# Chapter 4

## Description of the amendments

It is proposed to amend the following features of the project:

Figure 4.1 Camellia foreshore to Rydalmere alignment and bridge amendment

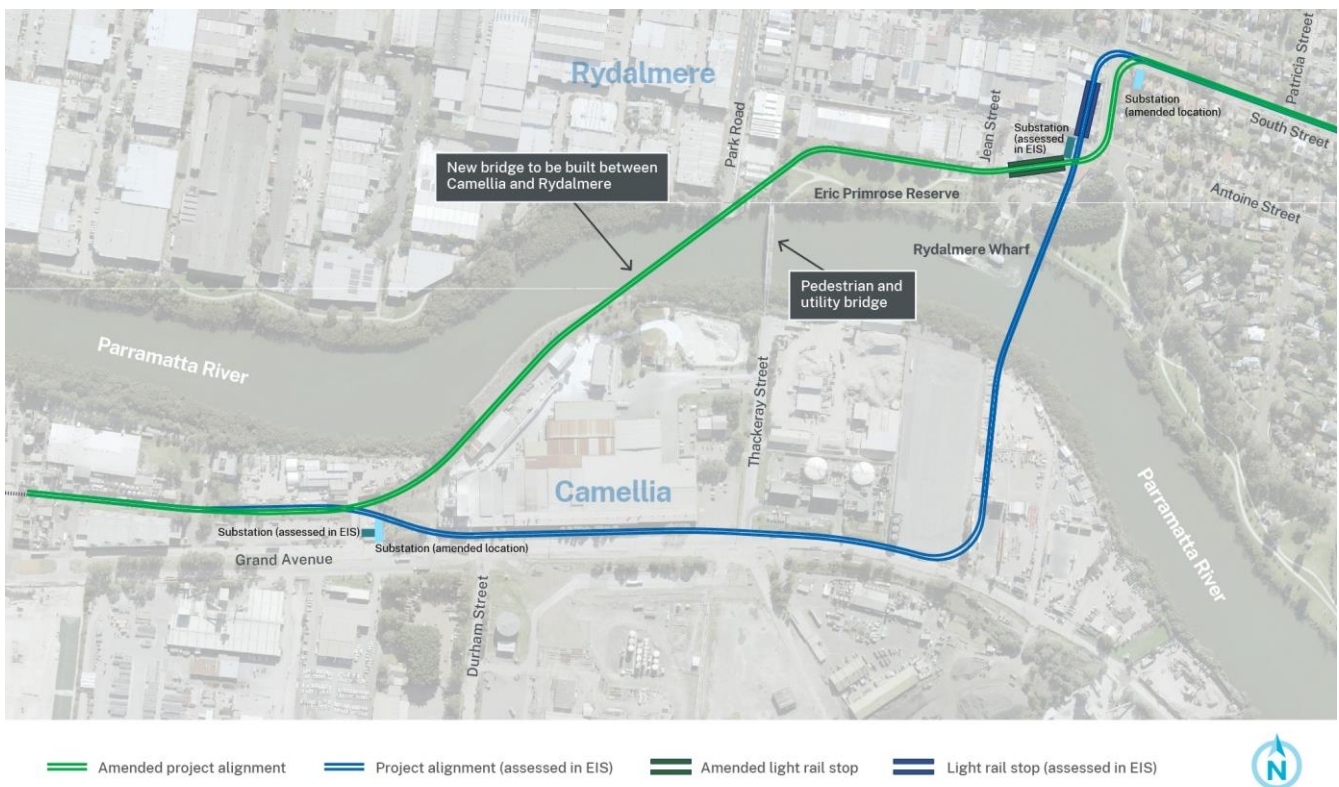
Figure 4.1 shows the new alignment and bridge compared to the exhibited project.

- light rail track, which would be located in an off-road (separated) arrangement along the Sandown Line corridor, crossing over the proposed bridge along an alignment further west (about 450 metres upstream) than shown in the EIS, extending along the northern edge of Eric Primrose Reserve on a raised embankment, continuing in an on-road (segregated) corridor along John Street before turning east onto South Street

- a five-span, concrete bridge about 260 metres long, with the northern abutment now located within the Sandown Line corridor, and the southern abutment located within Eric Primrose Reserve to the south of Park Road

- three bridge piers within the Parramatta River and a fourth pier located on the riverbank at the southern end of Park Road
- an active transport link located on the western side of the bridge with a separate exit ramp off the bridge to connect with the Parramatta Valley Cycleway and local footpaths

- a light rail stop (the John Street stop) located closer to Rydalmere Wharf than shown in the EIS
- road network changes to Park Road (adjusted turning circle) and John Street, South Street and Antoine Street (changed traffic lanes and new signalisation)

- a traction power substation in Rydalmere, located on the corner of John Street and South Street rather than on the corner of John Street and Antoine Street as shown in the EIS

- a traction power substation on Grand Avenue in Camellia, located slightly east of the location shown in the EIS, in a property already nominated as part of the land requirements for the project

Figure 4.3 Bridge at Hill Road amendment

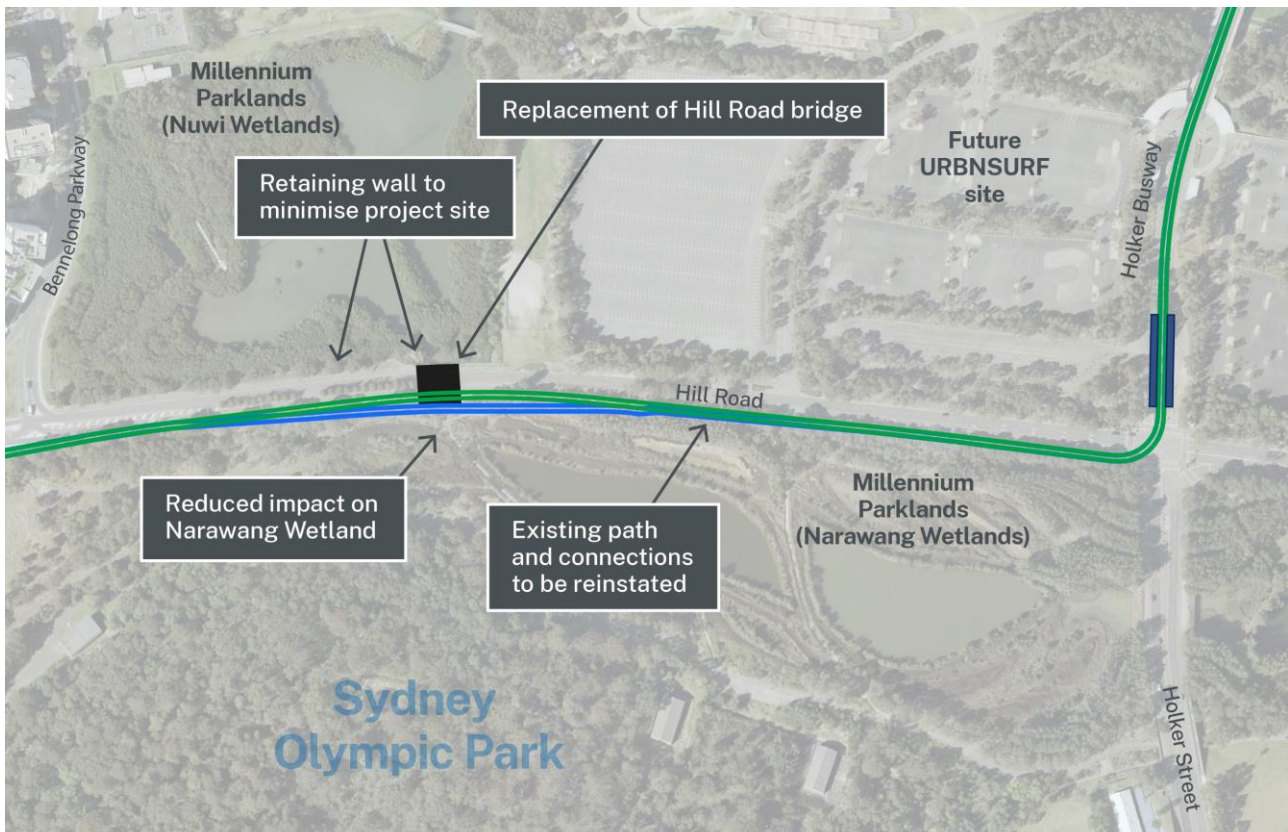
Figure 4.3 shows the new bridge compared to exhibited project.

- construction of a new single span, concrete bridge structure, about 20 metres long and 29 metres wide
- light rail tracks in each direction on the western side of the bridge, with two traffic lanes in each direction in the centre of the bridge and an active transport link on the eastern side
- a retaining structure on the eastern side of Hill Road to manage the differences between the existing ground level and light rail alignment (up to about 2.7 metres high)
- reinstatement of existing active transport connections
- utility relocation and adjustments.

- The existing Hill Road bridge would be removed.
- Additional temporary traffic changes would be required to facilitate bridge works (combination of short-term closures and contraflow arrangements).

Figure 4.4 Refinement of substation location at Atkins Road stop

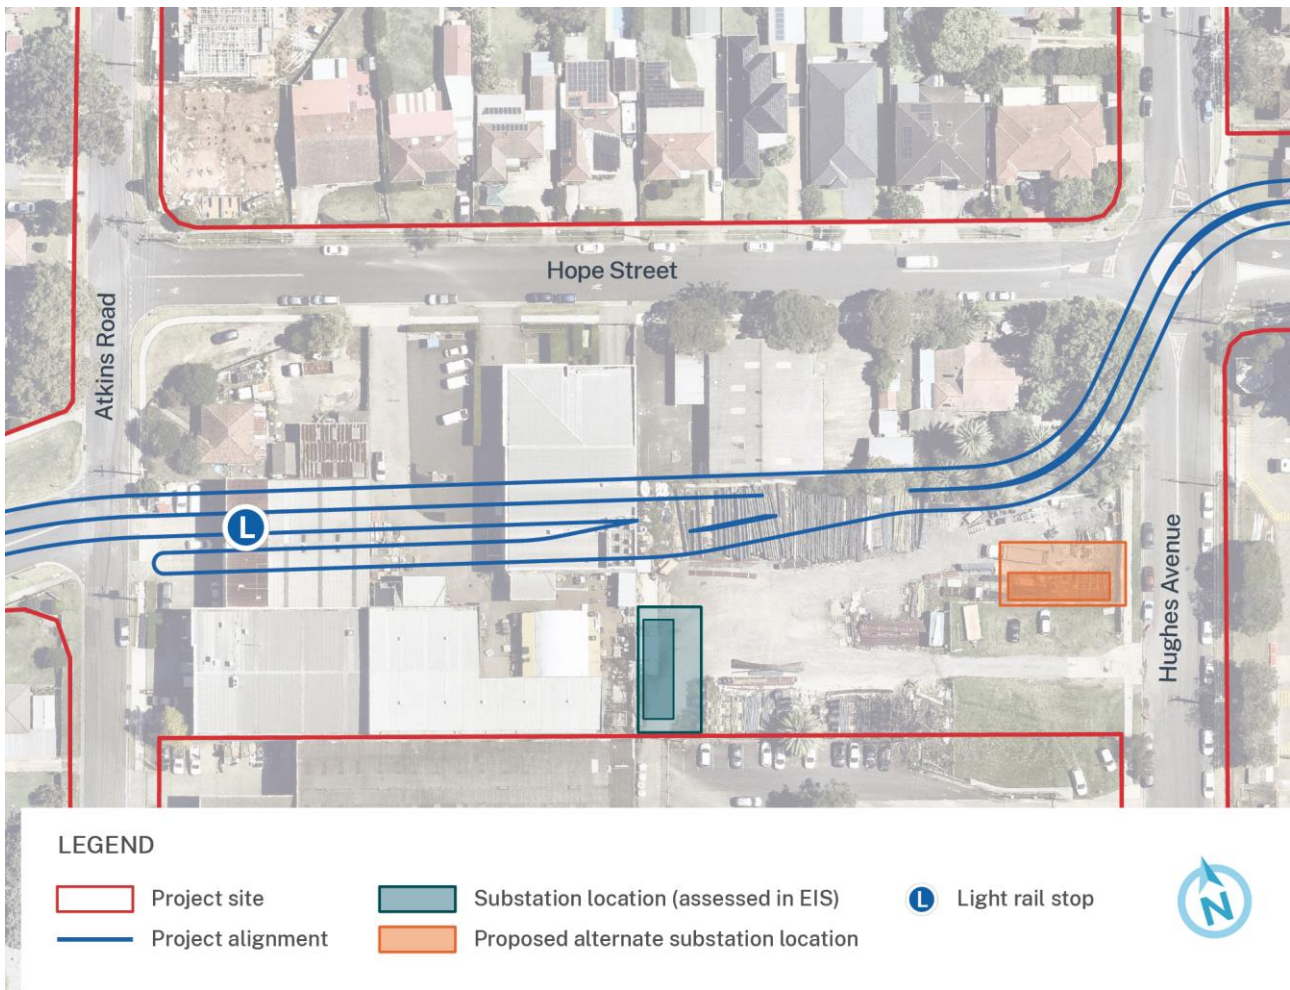
As part of design development, the substation in Melrose Park is proposed to be relocated to provide more direct access for maintenance vehicles, improve pedestrian connectivity, and avoid future conflicts with pedestrian links proposed as part of the *Melrose Park Southern Structure Plan* (City of Parramatta Council, 2019).

The proposed substation location is now about 50 metres further east, adjacent to Hughes Avenue. The relocated substation is within the project site boundary. The substation's purpose and infrastructure remains the same as described in section 6.7.4 of the EIS.

The substation location assessed in the EIS and the proposed refinement to this location are shown in Figure 4.4.
